RESOLUTION NO. R 2262

A RESOLUTION OF THE CITY OF KIRKLAND APPROVING AMENDMENT AND MODIFICATION OF SUBSTANTIAL DEVELOPMENT PERMIT PREVIOUSLY AUTHORIZED BY RESOLUTION NO. R2252 AND AUTHORIZING TRANSFER OF SAID PERMIT FROM DEAN CHAUSSEE TO S & H BUILDERS COMPANY.

MOSS BAY APARTMENTS  
 (Pleasant Bay Apartments)  
 SDP-74-8(H)  
 Revised Site Plan R-2262

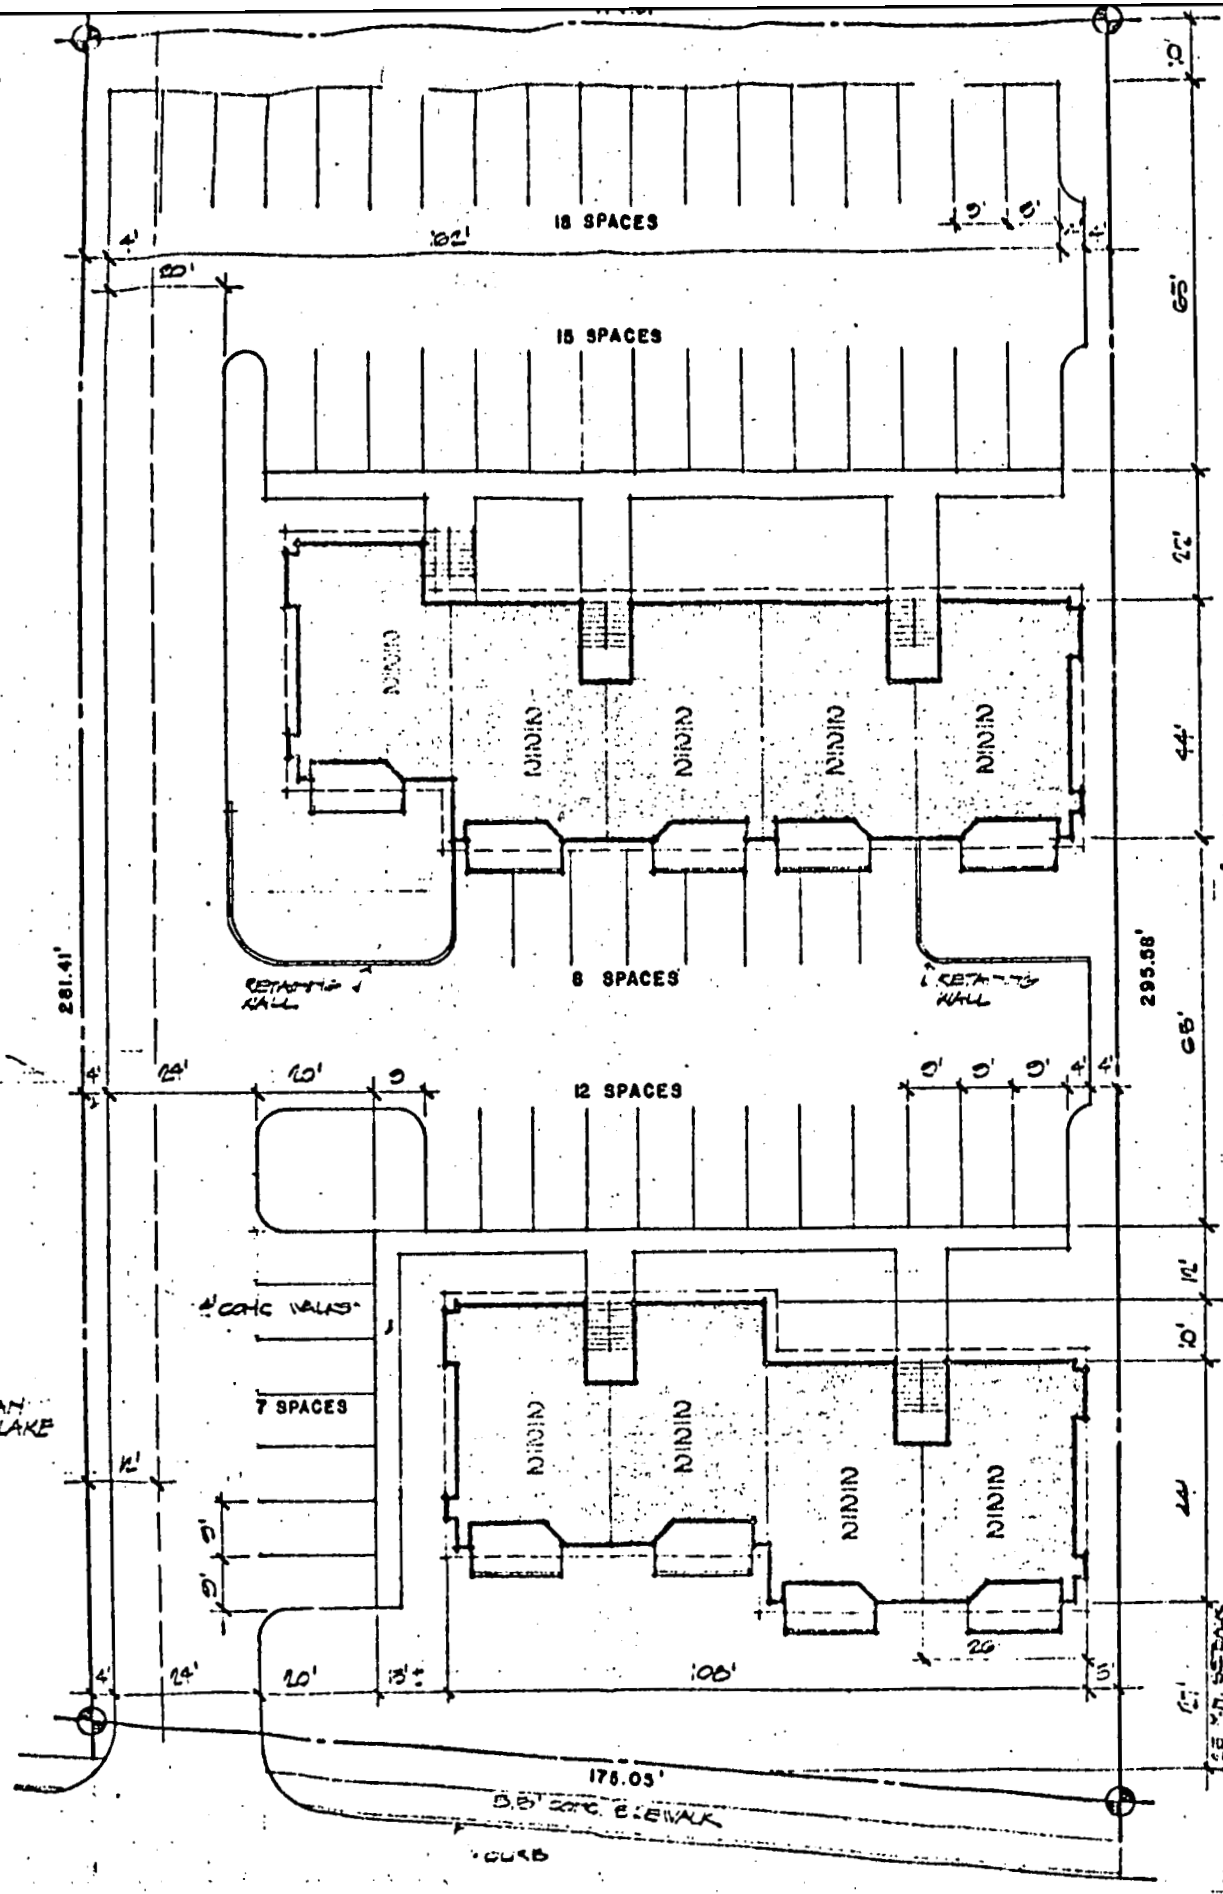
WHEREAS, in the course of said transfer it was discovered by survey that the north-south dimension of said property is approximately six and one-half feet less than appeared on the original application, and that as a result thereof, the area under appropriate zoning can accommodate 27 units, rather than 30 units, and

WHEREAS, S & H Builders Company has applied to the City for a modification and amendment of the Substantial Development Permit to reduce the total number of apartment units all as appears on Exhibit A attached to the original of this Resolution, and

Section 1. The Substantial Development Permit heretofore issued as Permit No. SDP-74-8(h) pursuant to Resolution No. R2252 adopted May 20, 1974 is hereby modified and amended in accordance with Exhibit A (amended site plan) and Exhibit B (corrected legal description and survey) attached to the
